CHULA VISTA Q/A MATRIX

Q #	Questions / Answers - SFO NO. VA-101-15-R-0052
1	<p>Q. Setback of 25 ft.: Is there any flexibility on this requirement? Assuming setbacks are established for security reasons and primarily vehicles ramming into the building and/or vehicles parked outside a building with explosives can the setback be mitigated by way of installing bollards or large planters? This would be primarily on the sides of the building where there is exposure to street or garage access.</p> <p>A. Yes, the setback can be mitigated by way of installing bollards, large planters or landscaping. The 25' setback is measured from the front outerwall of the building and not the sides of the building. The setback requirement is waived for existing buildings only. CORRECTION: Disregard the strike-through information. After further verification with VA's CFM Resident Engineer it has been determined that the 25' setback is for the ENTIRE perimeter of the building, not only the front of the building. Per Department of Veterans Affairs Physical Security Design Manual 2015.</p>

Part I: Basic Solicitation Requirements – Page 113 of 214

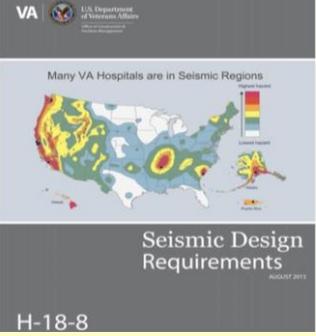
50 **Q.** Seismic: On page 113 of the SFO, it states that VA classifies CBOCs as "essential" or "critical" facilities. However, the VA design guidelines from 2013 (H-18-8) indicates in Table 3 that Outpatient Clinics are considered "Ancillary Facilities". Would you please clarify?

A. Provide per SFO requirement Section 6.1.4. Design as Essential facility.
